# **NORTH HYKEHAM RELIEF ROAD REPEAT STAGE 1 ROAD SAFETY AUDIT REPORT A46 HYKEHAM ROUNDABOUT**

Project name **North Hykeham Relief Road**  
 Project no. **1620013942**  
 Recipient **Balfour Beatty & Lincolnshire County Council**  
 Document type **Report**  
 Revision **C01**  
 Date **10/06/24**  
 Prepared by **S.Hawley**  
 Checked by **G.Turner**  
 Approved by **S.Hawley**  
 Document no. **NHRR-RAM-HGN-HYKE-RP-CH-01027**  
 Suitability Status **A4 - Approved & Accepted at Stage 4**

# LCC & NH PROBLEM LOCATION PLAN

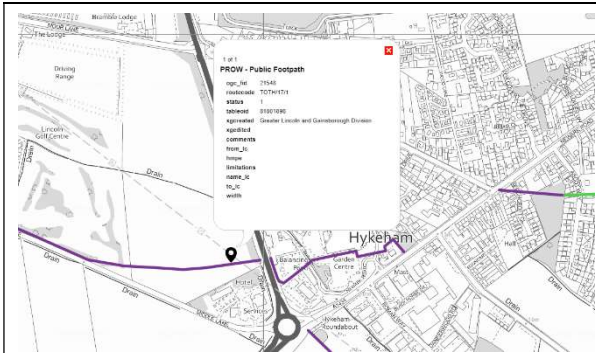
<b>PROBLEM 1 NH</b>	
<b>Location:</b>	A46 southbound carriageway towards Hykeham Roundabout (Location 1 NH on Plan in Appendix 1)
<b>Plan:</b>	NHRR-RAM-HGN-HYKE-DR-CH-00011 P04
<b>Summary:</b>	Single lane approach increases to four lanes over a short distance resulting in late lane changes and side-swipe collisions with personal injury occurring.
<p>The southbound A46 approach to the Hykeham Roundabout diverges from a single lane carriageway into four lanes over a short distance of approximately 40 metres and a physical separation island is to be provided between lanes 2 and 3. There is a concern that the rapid increase in the number of lanes may result in late / sudden lane changing manoeuvres being undertaken with possible vehicle / vehicle or vehicle / splitter island side-swipe or loss of control type collisions occurring leading to personal injury. It is noted that the speed limit on the A46 in this location is the national speed limit (60mph).</p>

<b>PROBLEM 2 NH</b>	
<b>Location:</b>	A46 southbound carriageway north of Hykeham Roundabout (Location 2 NH on Plan in Appendix 1)
<b>Plan:</b>	NHRR-RAM-HGN-HYKE-DR-CH-00011 P04
<b>Photograph</b>	Photo E (Appendix 2)
<b>Summary:</b>	Limited space available to provide adequate advance road signing for drivers approaching Hykeham Roundabout leading to possible driver confusion with late lane changing and side-swipe type collisions occurring with personal injury.
<p>There appears to be limited (verge) space available to allow adequate advance road signing to be installed for A46 southbound drivers approaching Hykeham Roundabout from the north. This may result in driver confusion and late decision making and lead to late lane changing resulting in side-swipe type collisions occurring with personal injury.</p>	
<b>RECOMMENDATION</b>	
<p>It is recommended that sufficient space should be made available so that clear advance wayfinding signs can be provided for drivers approaching the roundabout junction. Where land availability issues may exist an alternative means of communicating the numerous lanes and destinations approaching drivers could take should be provided.</p>

<b>PROBLEM 1 NH LCC</b>	
<b>Location:</b>	Middle Lane – Southern entrance to service area (Location 1 NH LCC on Plan in Appendix 1).
<b>Plan:</b>	NHRR-RAM-HGN-HYKE-DR-CH-60101 P01
<b>Summary:</b>	Entrance to service area (right turn lane) is in close proximity to the roundabout junction which may result in shunt/side-swipe type collisions and personal injury.
<p>The diverge right-turn lane and entrance to the service area is less than 30m from the roundabout gyratory which may result in shunt/side-swipe type collisions taking place as vehicles leaving the roundabout suddenly brake to turn right into the service entrance or they are unable to maintain the required lane discipline. Furthermore, the vehicle tracking drawing shows the turning manoeuvre NHRR-RAM-HGN-HYKE-DR-CH-60101) overrunning both lane markings and the offside hatch markings indicating insufficient road space for this manoeuvre to be satisfactorily undertaken and leading to sharp turns with loss of control and possible personal injury occurring. It is noted that the layout that was the subject of the original Stage 1 RSA proposed to relocate the entrance to the service area away from the roundabout, and only exiting was permitted in close proximity to the roundabout junction.</p>

<b>PROBLEM 2 NH LCC</b>	
<b>Location:</b>	Middle Lane – Proposed NUM route (combined footway/cycleway) (Location 2 NH LCC on Plan in Appendix 1).
<b>Plan:</b>	NHRR-RAM-HGN-HYKE-DR-CH-00011 P04
<b>Photograph</b>	Photo A (Appendix 2)
<b>Summary:</b>	Risk of NMU / vehicle collisions when crossing Middle Lane to access proposed combined NMU facilities with possible personal injury.
<p>NMUs crossing Middle Lane, i.e. from the service area and the realigned footpath (TOTH/17/1) to the combined NMU facilities proposed as part of the works are provided with no means to safely cross this carriageway. There is a concern that NMUs may attempt to cross at an inappropriate location leading to trip, falls or collisions with passing vehicles. This may lead to personal injury.</p>	
<b>RECOMMENDATION</b>	
<p>Appropriate crossing facilities of Middle Lane with wayfinding should be provided to allow connectivity to other proposed at-grade NMU facilities forming part of this scheme.</p>

<b>PROBLEM 3 NH LCC</b>	
<b>Location:</b>	Hykeham Roundabout splitter islands (Location 3 NH LCC on Plan in Appendix 1).
<b>Plan:</b>	NHRR-RAM-HGN-HYKE-DR-CH-00011 P04
<b>Summary:</b>	No NMU routes (combined footway/cycleway) have been indicated across the various roundabout splitter islands. This may result in trips/falls or NMUs being struck by a passing vehicle resulting in personal injury.
<p>No NMU routes (combined footway/cycleway) have been indicated across the various roundabout splitter islands forming part of the proposed works. A lack of connectivity between crossing facilities may result in NMU confusion while crossing the various splitter islands and lead to NMUs taking short-cuts with a risk of trips/falls or being struck by a passing vehicle resulting in personal injury.</p>	
<b>RECOMMENDATION</b>	
<p>Appropriate routes across splitter islands with wayfinding should be provided for NMUs.</p>

<b>PROBLEM 4 NH LCC</b>	
<b>Location:</b>	A1434 Newark Road westbound carriageway towards Hykeham Roundabout near side entry radius (Location 4 NH LCC on Plan in Appendix 1).
<b>Plan:</b>	NHRR-RAM-HGN-HYKE-DR-CH-00011 P04
<b>Summary:</b>	W/B near side entry radius is 'tight' and this may result in side-swipe type collisions occurring.
<p>The A1434 Newark Road on the W/B approach to Hykeham Roundabout consist of a nearside entry radius which is approximately 20m. This left-hand radius is then followed by an opposing right hand radius curve associated with the roundabout gyratory. This nearside horizontal alignment may result in poor lane discipline and vehicles heading towards the exit to NHRR and not keeping to lane 1 of the gyratory. The lack of lane discipline may result in vehicles drifting into an opposing lane with a subsequent risk of side-swipe type collisions occurring with personal injury. It is noted that there is not a vehicle swept path shown for this manoeuvre on the tracking drawings provided.</p>

<b>PROBLEM 5 NH LCC</b>	
<b>Location:</b>	A46 verges / Middle Lane northern verge unofficial worn path (Location 5 NH LCC on Plan in Appendix 1).
<b>Plan:</b>	NHRR-RAM-HGN-HYKE-DR-CH-00011 P04
<b>Photograph</b>	Photos B and C (Appendix 2)
<b>Summary:</b>	Risk of NMU / vehicle collisions while crossing A46 between services area and restaurant.
<p>During the site visit the Audit Team noted that there is a well-worn track along the northern verge of Middle Lane (leading from the Travel Lodge Hotel) up to the western side of the A46. The worn track continues on the eastern side of the A46 up to the 'Hickory Smokehouse' restaurant. The scheme proposals do not appear to accommodate the associated existing pedestrian movements which post-completion will result in longer crossing distances owing to the increased number of lanes. Should these movements continue with no dedicated specific crossing facilities being provided across the A46, there is a concern that pedestrian/vehicle conflicts may occur leading to pedestrian injury.</p>

<b>PROBLEM 6 NH LCC</b>	
<b>Location:</b>	A46 S/B approach the Hykeham Roundabout (Location 6 NH LCC on Plan in Appendix 1).
<b>Plan:</b>	NHRR-RAM-HGN-HYKE-DR-CH-00011 P04
<b>Summary:</b>	Limited visibility to both primary traffic signals may result in shunt type collisions occurring.
<p>The southbound A46 approach to the Hykeham Roundabout consists of a four lane entry together with the Subsidiary Deflection Island (SDI) at the stop line, the overall carriageway width being approximately 18m. The Audit Team accepts that at least one primary traffic signal shall be visible for an approaching driver at a distance equivalent to the stopping sight distance (SSD).</p> <p>Whilst two primary signals are expected to be provided at the stop line, with both likely to be displaying the same information, there is a concern that given the wide entry drivers wishing to access Lanes 1 and 2 will be focusing their attention more on the nearside rather than the off-side primary traffic signal which itself could be obscured by queuing vehicles.</p> <p>No SSD drawing has been provided within the RSA Brief but there is a concern that forward visibility to the nearside primary signal may be masked by vegetation or development beyond the red line boundary. The lack of forward visibility, especially to the nearside primary signal may result in drivers failing to see queuing traffic with a subsequent risk of shunt type collisions occurring with personal injury.</p> <p>It is noted that the speed limit on the A46 in this location is the national speed limit (60mph).</p>

<b>PROBLEM 7 NH LCC</b>	
<b>Location:</b>	Hykeham Roundabout circulatory carriageway (Location 7 NH LCC on Plan in Appendix 1).
<b>Plan:</b>	NHRR-RAM-HGN-HYKE-DR-CH-01020 P06
<b>Summary:</b>	Limited forward visibility at entry and on the circulatory carriageway may result in shunt type collisions occurring.
<p>The drawing information provided indicates that landscaping planting is to be provided and that some of the visibility splays may encroach into the landscape areas of the central island. During the growing season the required forward visibility may not be achievable resulting in shunt type collisions occurring with personal injury.</p> <p>It is noted that there are no stopping sight distance drawings provided within the RSA brief.</p>	
<b>RECOMMENDATION</b>	
It is recommended that measures are introduced to reduce the risk of shunt type collisions, or late breaking for a red aspect traffic signal.

<b>PROBLEM 8 NH LCC</b>	
<b>Location:</b>	NHRR N/B approach the Hykeham Roundabout (Location 8 NH LCC on Plan in Appendix 1).
<b>Plan:</b>	NHRR-RAM-HML-HYKE-DR-CH-01020 P06
<b>Summary:</b>	Limited visibility to both primary traffic signals may result in shunt type collisions occurring.
<p>The NHRR on the N/B approach to Hykeham Roundabout consists of a two-lane segregated left turn lane (SLTL) with a left diverge arrow provided at the diverge taper.</p> <p>Drivers may not have sight of either primary signals associated with the SLTL at the desirable minimum stopping sight distance with both signals possibly being masked by vegetation on the approach to the junction.</p> <p>The lack of forward visibility of both signals may result in vehicles failing to see queuing traffic with a subsequent risk of shunt type collisions occurring with personal injury.</p> <p>It is noted that there are no stopping sight distance drawings provided within the RSA brief.</p>

<b>PROBLEM 9 NH LCC</b>	
<b>Location:</b>	NHRR N/B approach the Hykeham Roundabout (Location 9 NH LCC on Plan in Appendix 1).
<b>Plan:</b>	NHRR-RAM-HML-HYKE-DR-CH-01020 P06
<b>Summary:</b>	2 lane diverge onto SLTL may result in side-swipe type collisions occurring.
<p>The NHRR on the N/B approach to Hykeham Roundabout consists of a two-lane segregated left turn lane (SLTL) with a left diverge arrow provided at the diverge taper.</p> <p>Drivers may diverge in a poor lane disciplined manner resulting in side-swipe type collisions occurring.</p> <p>It is noted that multi-lane SLTL are not permitted in the design standard DMRB CD116 and no departure from standard has been referenced within the RSA Brief.</p>	
<b>RECOMMENDATION</b>	
It is recommended that measures are introduced to reduce the risk of side-swipe type collisions due to the provision of a multi-lane SLTL.

<b>RECOMMENDATION</b>	
<p>It is recommended that the transition length (distance) over which the single lane diverges into four lanes should be increased and advance road signing and markings should be provided to indicate to drivers the layout of the roundabout junction ahead, along with the possible destinations, so that early decisions can be made leading to better lane discipline.</p>

<b>RECOMMENDATION</b>	
It is recommended that the entrance should be relocated further from the roundabout junction and clear advance signing directing drivers to the service area should be provided.

<b>RECOMMENDATION</b>	
<p>Provide a nearside horizontal alignment that avoids the risk of vehicles drivers not maintaining the correct lane discipline. The manoeuvre should be tracked at an appropriate vehicle speed.</p>

<b>RECOMMENDATION</b>	
<p>It is recommended that appropriate NMU crossing facilities should be provided to cater for the existing user demand.</p>

<b>RECOMMENDATION</b>	
It is recommended that measures are introduced to reduce the risk of shunt type collisions due to queuing traffic, or late breaking for a red aspect traffic signal.

<b>RECOMMENDATION</b>	
It is recommended that measures are introduced to reduce the risk of shunt type collisions due to queuing traffic, or late breaking for a red aspect traffic signal.
